UNITED STATES PATENT AND TRADEMARK OFFICE

APPLICATION NO.	FILING DATE	FIRST NAMED INVENTOR	ATTORNEY DOCKET NO.	CONFIRMATION NO.
10/734,495	12/12/2003	John H. Crume	205017-9012-00	1616

Office Action Summary	Application No.	Applicant(s)	
	10/734,495	CRUME ET AL.	
	Examiner	Art Unit	
	Mariano Sy	3683

DETAILED ACTION

See attached Fig. 4 below.

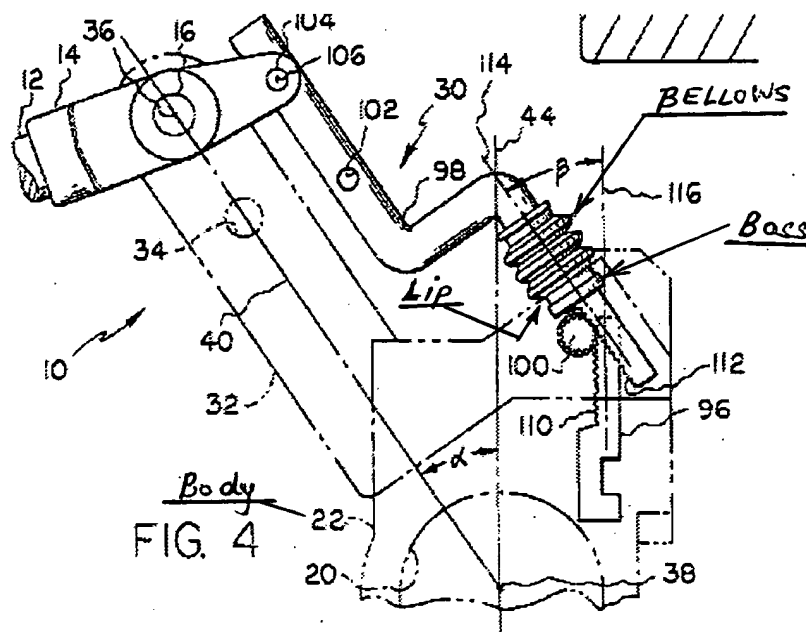
Applicant argued in the Remarks that "it cannot be determined from figure 4, or elsewhere in the patent, whether the boot has a seal with a boss or if any portion of the boot is inserted into the body of the slack adjuster".

Lyons '302 disclose, as shown in Fig. 1, a slack adjuster 10, a housing or body 22, an outer part link 98, a boot or bellows (between "98" and "100"). In Fig. 4 the housing or body 22 (shown in phantom lines for reference) clearly shows the boot or bellows, covering the outer part link 98, is inserted into the body 22 through a cavity inside the body for link 98 to engage with gear 100. A boss (facing near "100") has an enlarged diameter than the next convolution (smaller in diameter) fitted behind a lip secured within the body (opening hole for the boot or bellows to be inserted into the body 22 in order the boot or bellows will not pull out or separate from the body during movement of outer part link 98 and to seal off dirt, moisture and contaminants.

Examiner maintains the rejection is proper.
